UNITED STATES ENVIRONMENTAL PROTECTION AGENCY

PCB Risk-Based Disposal Approval under 40 CFR § 761.61(c)

Former Garbose Metal Company Property 155 Mill Street, Gardner, Massachusetts

MassDEP RTN: 2-11321

Attachment 2: Figure 1, Modified Proposed Excavation Plan Attachment 3: Revised Figure 2, Proposed Consolidation Plan

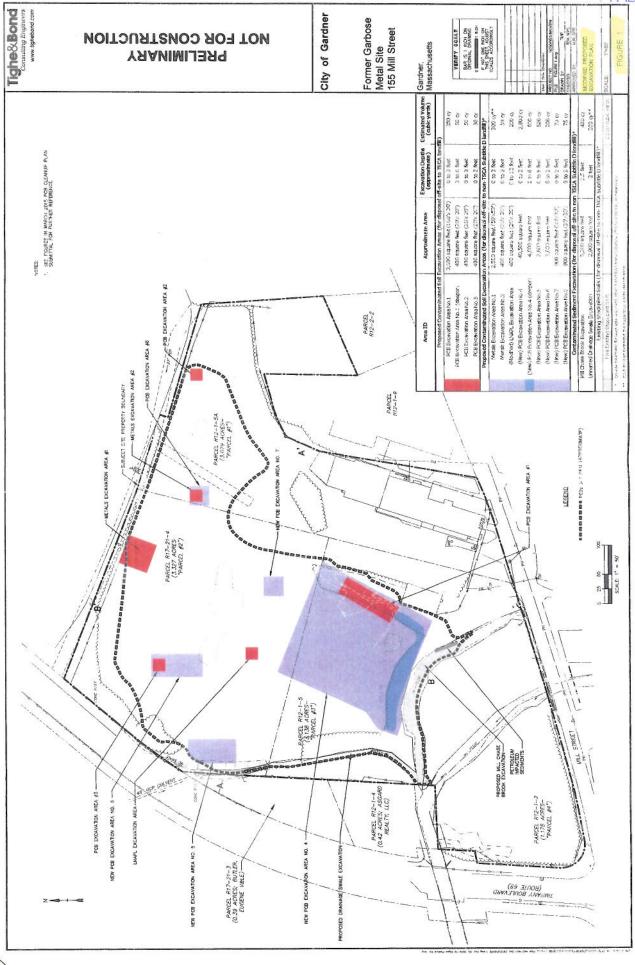
- ⇒ Excavate and dispose off-site, soil with greater than or equal to ("≥") 10 ppm PCBs and soil with metals greater than the Massachusetts Contingency Plan ("MCP") Method 3 Upper Concentrations Limits ("UCL"). In the event that funding does not provide for removal of all ≥ 10 ppm PCBs, contaminated soil with ≥ 25 ppm PCBs shall be excavated and disposed off-site;

- ⇒ Excavate and relocate PCB-contaminated soil with ≥ 1 ppm but < 10 ppm into the Contaminated Soil Consolidation Area as shown on Figure 2 of the January 5, 2016 PCB Cleanup Plan Addendum 1;

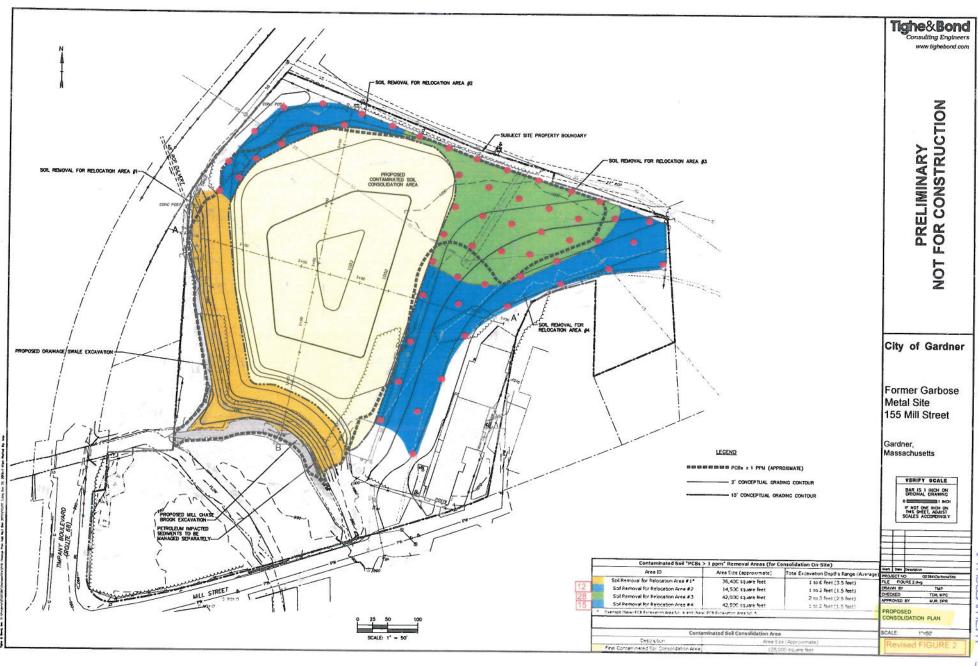
- ⇒ Demolish existing concrete structures. Demolish and relocate unpainted/unstained building concrete floors with PCB concentrations less than ("<") 10 parts per million ("ppm") into the Contaminated Soil Consolidation Area as shown on revised Figure 2 of the Notification;
- ⇒ Remove and dispose off-site the five (5) PCB-contaminated soil stockpiles with PCB concentrations greater than (">") 1 ppm but < 50 ppm;
